TECHNICAL BULLETIN

412-23-249

MODEL AFFECTED: 412EP

SUBJECT: LIGHT DIMMING RESISTORS, REWIRING AND RETROFIT OF

**Figure 1 (sheet 1 of 2)
Variable Resistor Replacement**

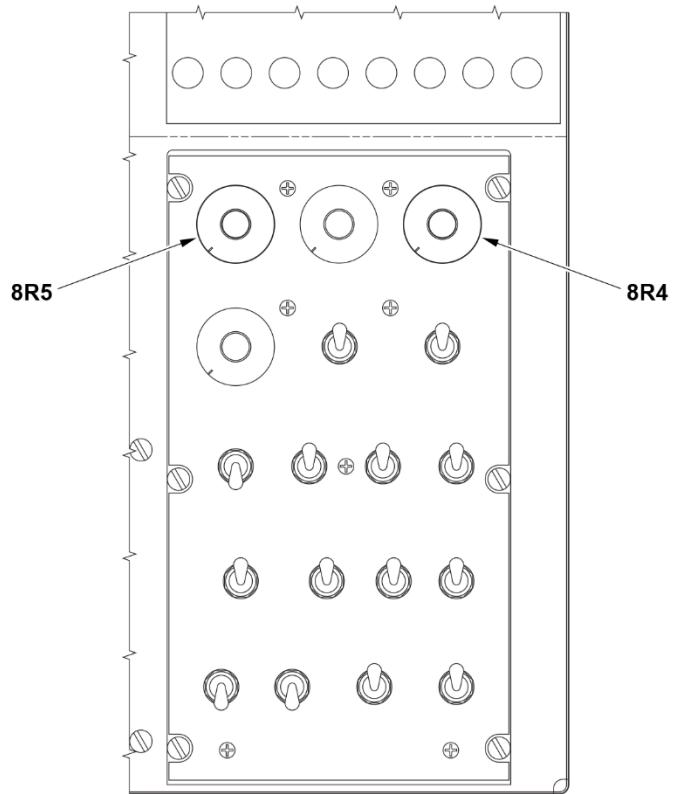
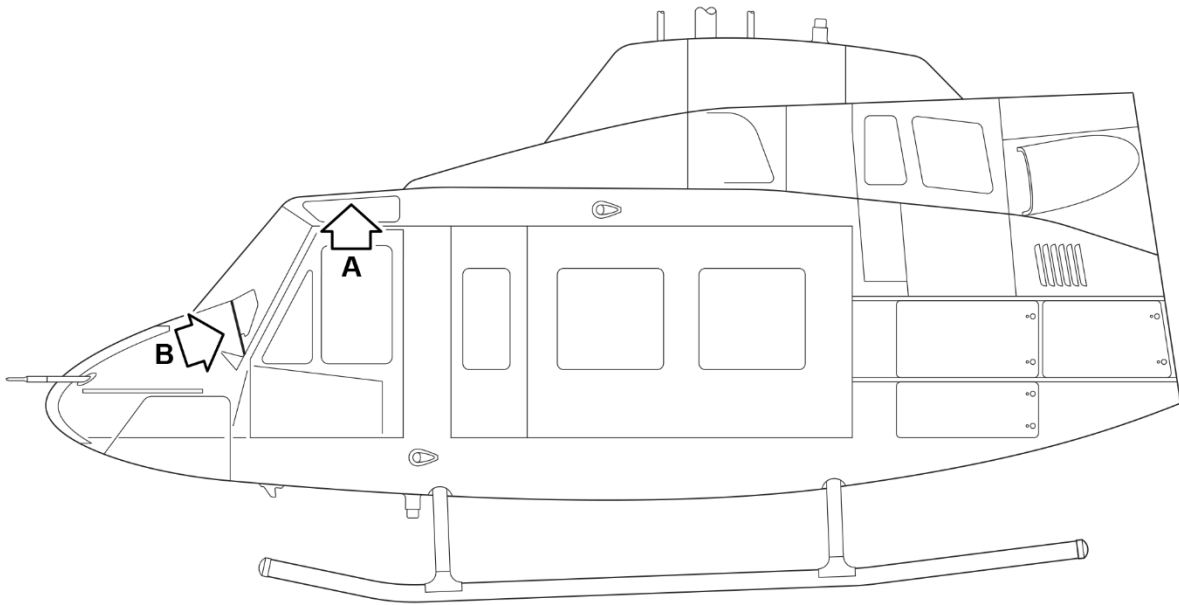
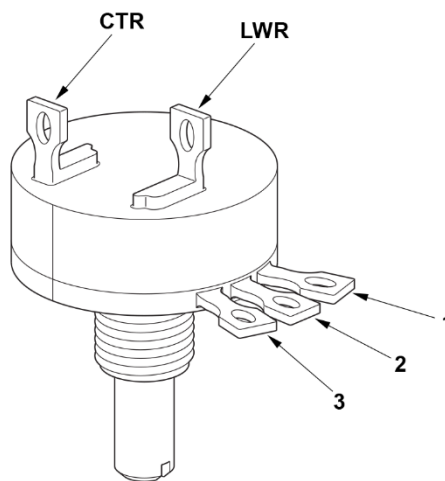
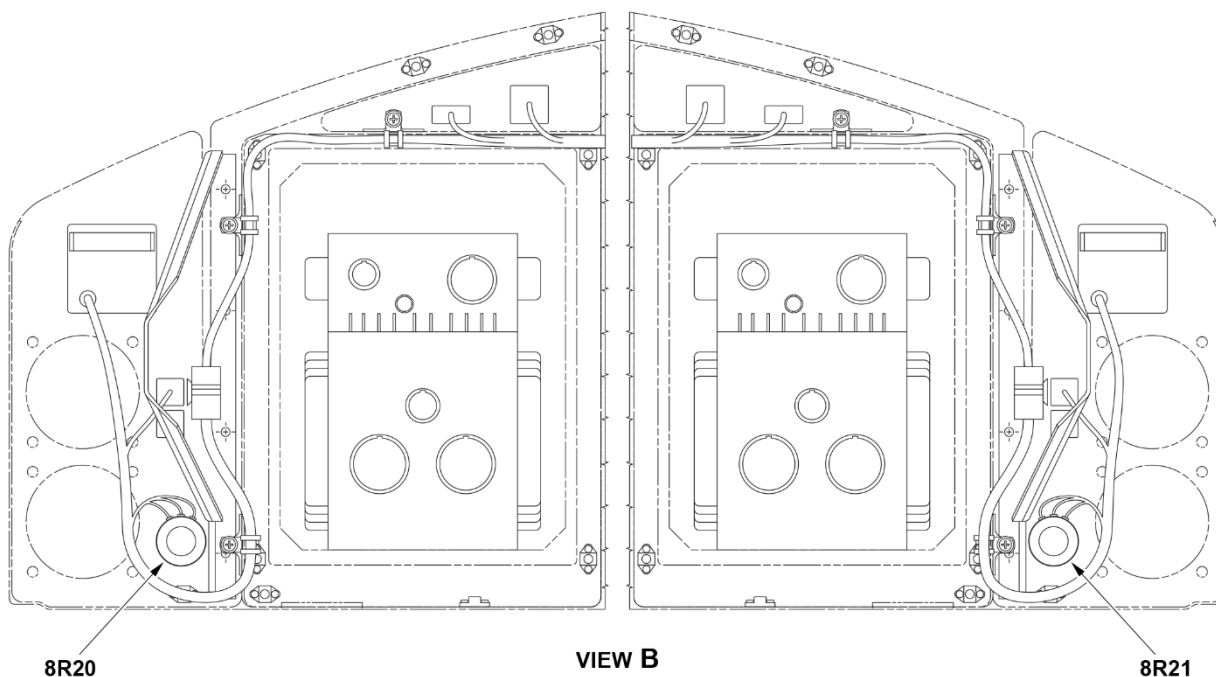
Lighting variable resistor 110-046-3 reference designators 8R4,8R5,8R20 and 8R21 are no longer procurable and are replaced by RV4NBYS102A. The replacement variable resistor does not have the same terminal arrangement for the wires. This Technical Bulletin provides the instructions to relocate the wires when replacing these variable resistors.

1. Prepare the helicopter for maintenance.
2. Access the secondary instrument light variable resistor, reference designator (Ref. Des.) 8R4 located in the overhead panel, refer to figures 1 and 2.
3. Remove variable resistor 110-046-3.
4. Install variable resistor RV4NBYS102A.

1. Prepare the helicopter for maintenance.
2. Access the overhead console lights variable resistor, Ref. Des. 8R5 located in the overhead panel, refer to figure 1 and 2.
3. Remove variable resistor 110-046-3.
4. Install variable resistor RV4NBYS102A.

1. Prepare the helicopter for maintenance.
2. Access the pilot approach plate and map light variable resistor, Ref. Des. 8R20 located on the instrument panel, refer to figure 1 and 2.
3. Remove variable resistor 110-046-3.
4. Install variable resistor RV4NBYS102A.

1. Prepare the helicopter for maintenance.
2. Access the copilot approach plate and map light variable resistor, Ref. Des. 8R21 located on the instrument panel, refer to figure 1 and 2.
3. Remove variable resistor 110-046-3.

Figure 2
Wiring Diagrams

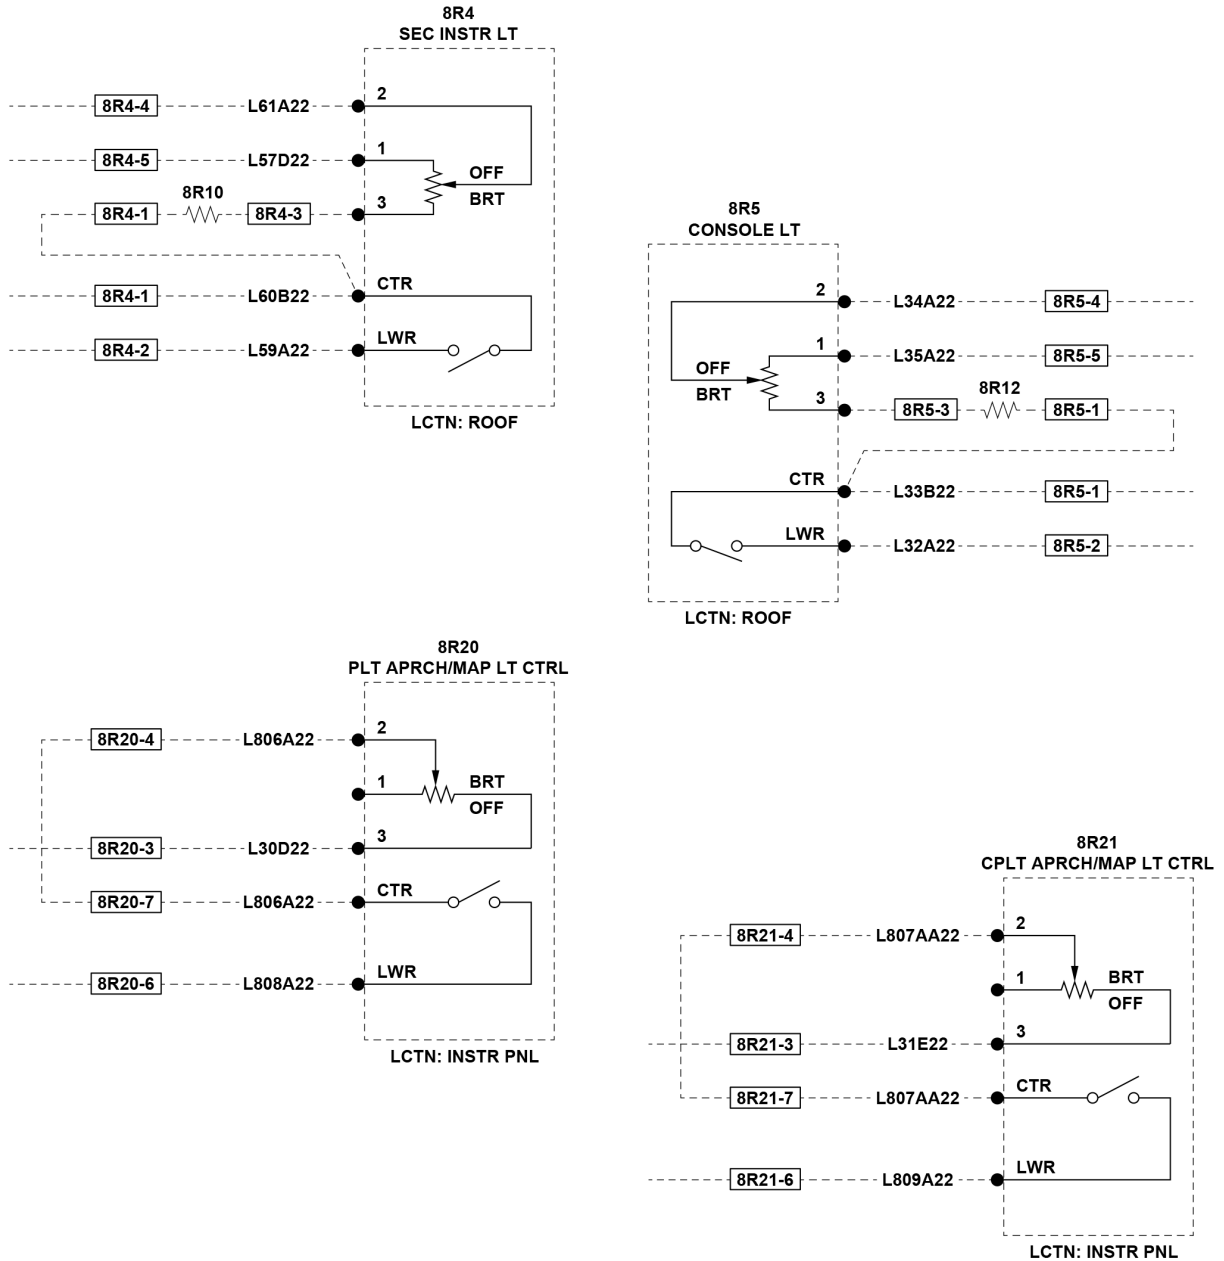
5. Remove wire L61A22 from 8R4-4 and relocate to 8R4-2.
6. Remove wire L57D22 from 8R4-5 and relocate to 8R4-1.
7. Remove resistor 8R10 from 8R4-1 and 8R4-3 and relocate to 8R4-CTR and 8R4-3.
8. Remove wire L60B22 from 8R4-1 and relocate to 8R4-CTR.

9. Remove wire L59A22 from 8R4-2 and relocate to 8R4-LWR.
10. Position the heat shrink tubing (C-589) over the variable resistor terminals and shrink with a heat gun.
11. Perform an operational check in accordance with BHT-412-MMS-EPI Maintenance Manual Supplement (DMC-412-A-96-63-03-04A-320A-A) or BHT-412-MMS-EPX Maintenance Manual Supplement (DMC-412-A-96-67-04-04A-320A-A)
12. Make an entry in the helicopter logbook indicating compliance with Part I of this Technical Bulletin.

5. Remove wire L34A22 from 8R5-4 relocate to 8R5-2.
6. Remove wire L35A22 from 8R5-5 relocate to 8R5-1.
7. Remove resistor 8R12 from 8R5-1 and from 8R5-3 and relocate to 8R5-CTR and 8R5-3.
8. Remove wire L33B22 from 8R5-1 relocate to 8R5-CTR.
9. Remove wire L32A22 from 8R5-2 relocate to 8R5-LWR.
10. Position the heat shrink tubing (C-589) over the variable resistor terminals and shrink with a heat gun.
11. Perform an operational check in accordance with BHT-412-MMS-EPI Maintenance Manual Supplement (DMC-412-A-96-63-03-05A-320A-A) or BHT-412-MMS-EPX Maintenance Manual Supplement (DMC-412-A-96-67-04-05A-320A-A).

5. Remove wire L806A22 from 8R20-4 relocate to 8R20-2.
6. Remove wire L30D22 from 8R20-3 reinstall to 8R20-3.
7. Remove wire L806A22 from 8R20-7 relocate to 8R20-CTR.
8. Remove wire L808A22 from 8R20-6 relocate to 8R20-LWR.
9. Position the heat shrink tubing (C-589) over the variable resistor terminals and shrink with a heat gun.
10. Perform an operational check in accordance with BHT-412-MMS-EPI Maintenance Manual Supplement (DMC-412-A-96-63-03-00A-320A-A) or BHT-412-MMS-EPX Maintenance Manual Supplement (DMC-412-A-96-67-04-00A-320A-A).
11. Make an entry in the helicopter logbook indicating compliance with Part III of this Technical Bulletin.

4. Install variable resistor RV4NBYS102A.
5. Remove wire L807AA22 from 8R21-4 relocate to 8R21-2.
6. Remove wire L31E22 from 8R21-3 reinstall to 8R21-3.
7. Remove wire L807AA22 from 8R21-7 relocate to 8R21-CTR.
8. Remove wire L809A22 from 8R21-6 relocate to 8R21-LWR.
9. Position the heat shrink tubing (C-589) over the variable resistor terminals and shrink with a heat gun.
10. Perform an operational check in accordance with BHT-412-MMS-EPI Maintenance Manual Supplement (DMC-412-A-96-63-03-00A-320A-A) or BHT-412-MMS-EPX Maintenance Manual Supplement (DMC-412-A-96-67-04-00A-320A-A).
11. Make an entry in the helicopter logbook indicating compliance with Part III of this Technical Bulletin.
